90. Ethernet Support for Time Synchronization Protocols

Changed to subclause 90.6 and 90.7 are marked in red

Figure 90–3—PHY latency measurement points

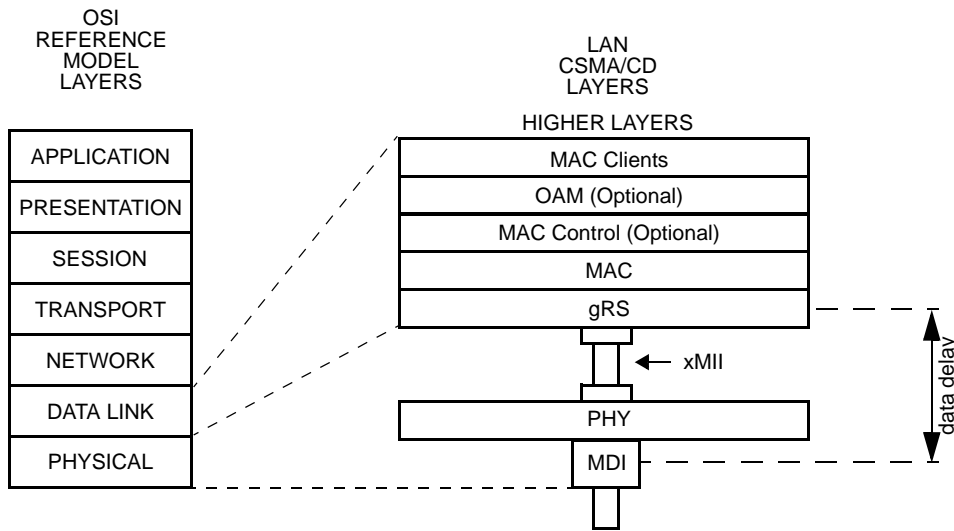
The optional TimeSync capability requires measurement of **data delay** in the transmit and receive **paths**, as shown in Figure 90–3. The transmit **path** data delay is measured from the input of the beginning of the SFD at the xMII to its presentation by the PHY to the MDI. The receive **path** data delay is measured from the input of the beginning of the SFD at the MDI to its presentation by the PHY to the xMII.

NOTE—the measured **data delay** in either the transmit or receive **path** should not include delay resulting from any length of the medium, regardless of the type of the medium used by the given PHY. It is observed however that even if any medium-imposed delay is included in the measured **data delay**, it does not affect the operation of the TimeSync functions and only shifts the timing reference point farther from the MDI.
